41-029: Donaldson Air Intake Filter Compatibility

41-029

A Donaldson air filter housing design change occurred that incorporates an alignment tab. If the incorrect air filter is installed, the tab can puncture the air filter seal.

Air filter compatibility: P621725 and P621730 (top right), P640016 and P640017 (bottom right)

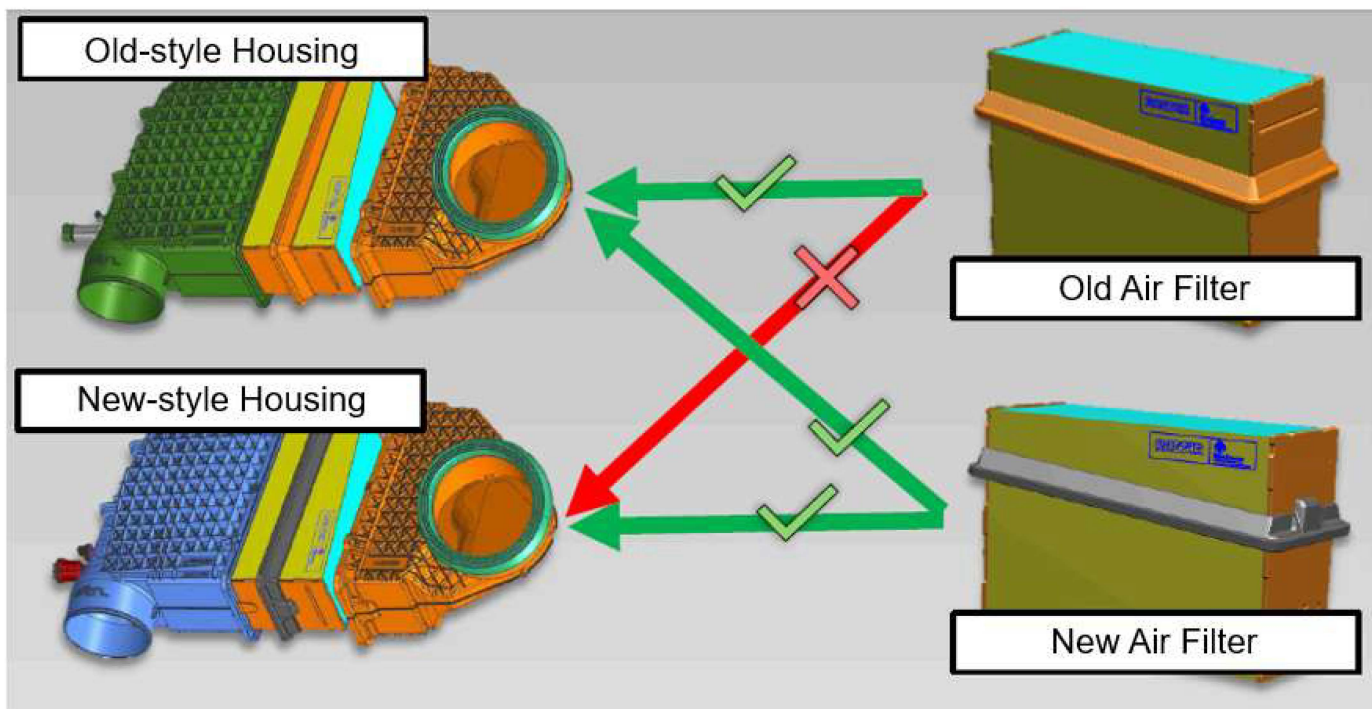
PACCAR air filters P640016 and P640017 can be used for both the new-style and old-style air filter housings.

PACCAR air filters P621725 and P621730 can only be used for the old-style air filter housing.

- New-style air filter housing: D37-1050(-00000)
- Old-Style air filter housing: D37-1032(-00000)

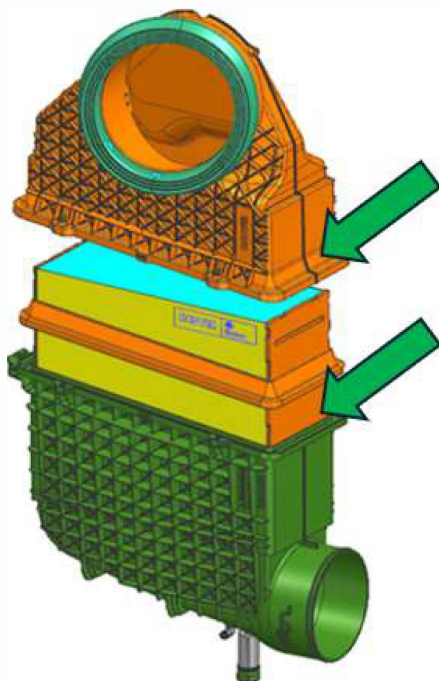
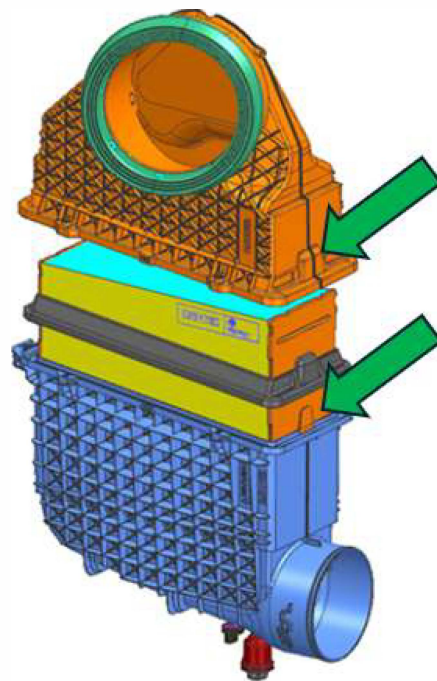
A Donaldson air filter housing design change occurred that incorporates an alignment tab. If the incorrect air filter is installed, the tab can puncture the air filter seal.

Dealers should make sure that only the correct air filter is being used in the new-style air filter housing. The new-style air filter housing should not be modified to accept the old-style air filters. Use of the incorrect air filter can result in engine damage.

Air filter compatibility: P621725 and P621730 (top right), P640016 and P640017 (bottom right)

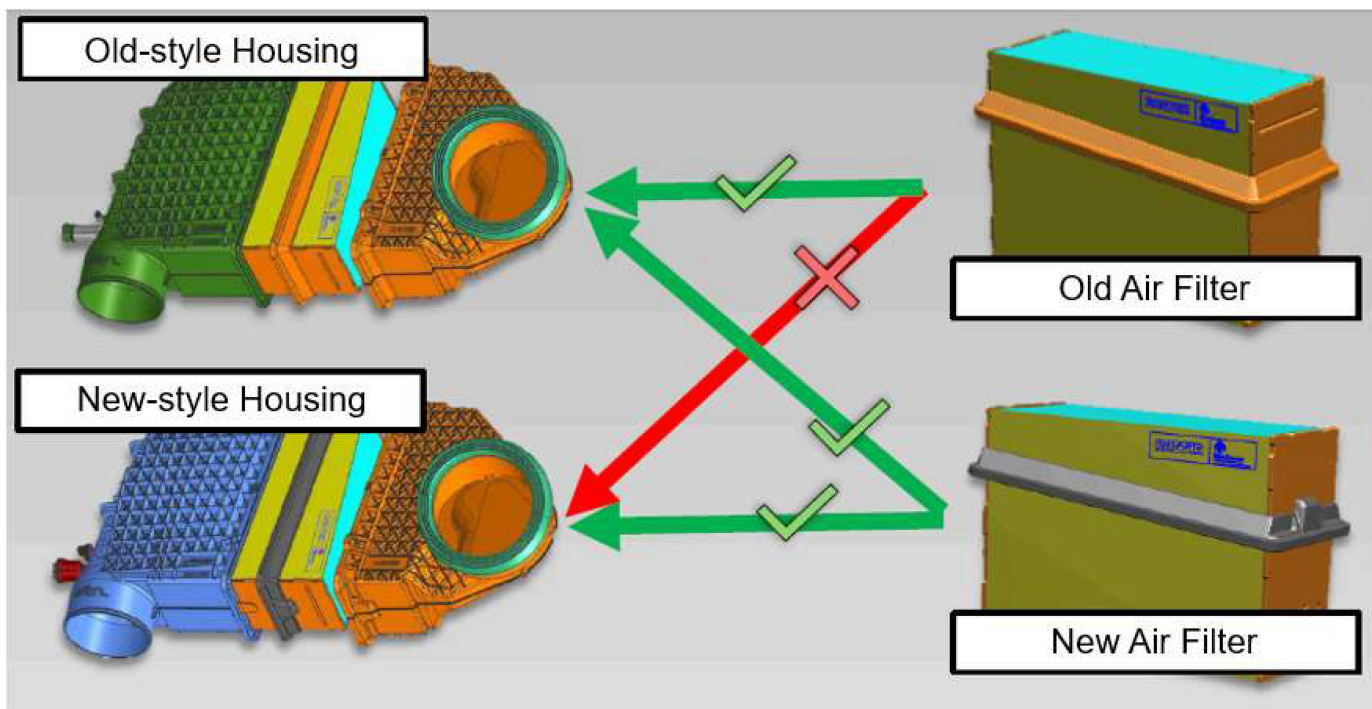
PACCAR air filters P640016 and P640017 can be used for both the new-style and old-style air filter housings.

PACCAR air filters P621725 and P621730 can only be used for the old-style air filter housing.

- New-style air filter housing: D37-1050(-00000)
- Old-Style air filter housing: D37-1032(-00000)
